REMARKS

The attached response includes a request to amend the drawings per the enclosed set and the above amendments to the specification to provide the clarifications requested by the examiner regarding the election of species and inconsistencies between the drawings and the specification. I believe that the attached amendments should place the application in condition for allowance.

FIG. 2 (Ex FIG. 4)

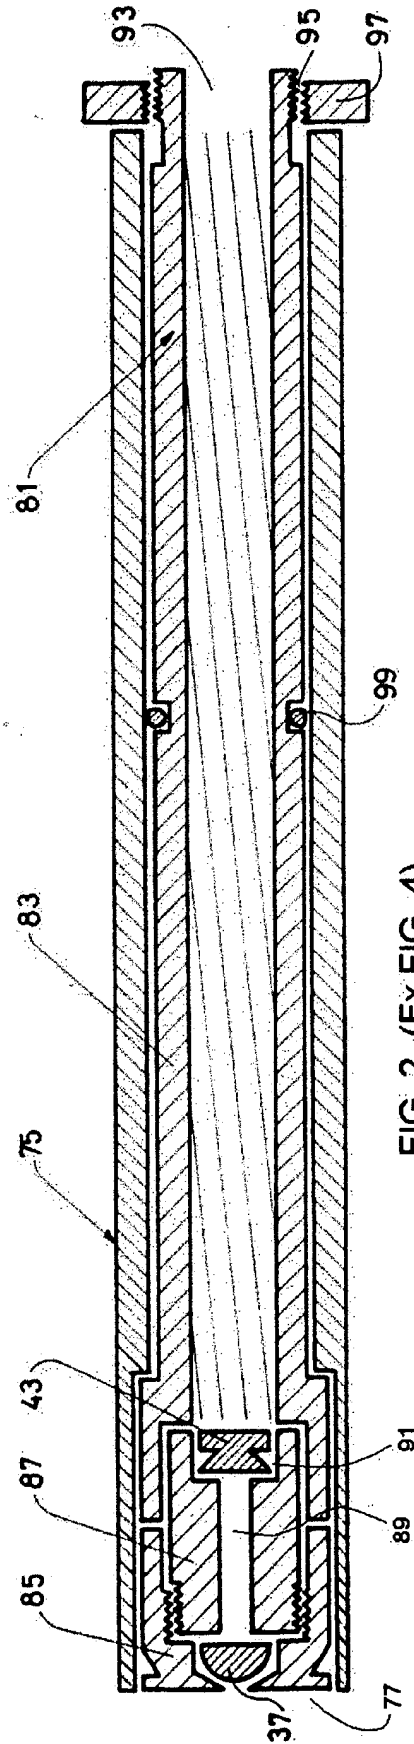
The set of drawings as filed contained figures 1-12. The examiner rightly noted inconsistencies between the drawings and the specification (page 2). I therefore propose to amend the drawings by cancelling figures 2-3 and 5-6, and renumbering figures 4 and 7-12 as figures 2 and 3-8, respectively. Reference numerals are added to renumbered figures 2-3 and 6 per the marked up drawing copies.

FIG. 3 (Ex FIG. 7)

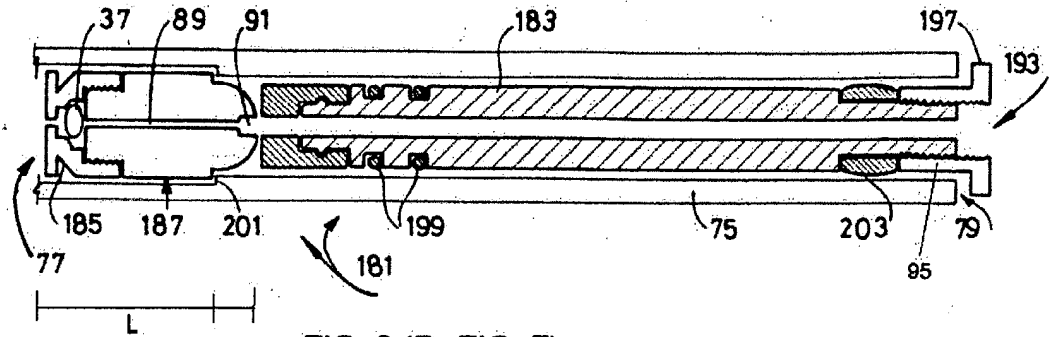
The examiner's assumption regarding the election of species is basically correct. I confirm for the record that I meant to elect species F and thus the examination based on former figure 7, now figure 3 is in order. This figure was and is described as figure 3 in the specification.

Claim 6 is amended to overcome the examiner's vagueness objection. The amendment to claim 6 is supported by the specification, page 11, lines 14-17. I propose to insert a dimension "L" in figure 3 to indicate the length of the dummy bullet 187.
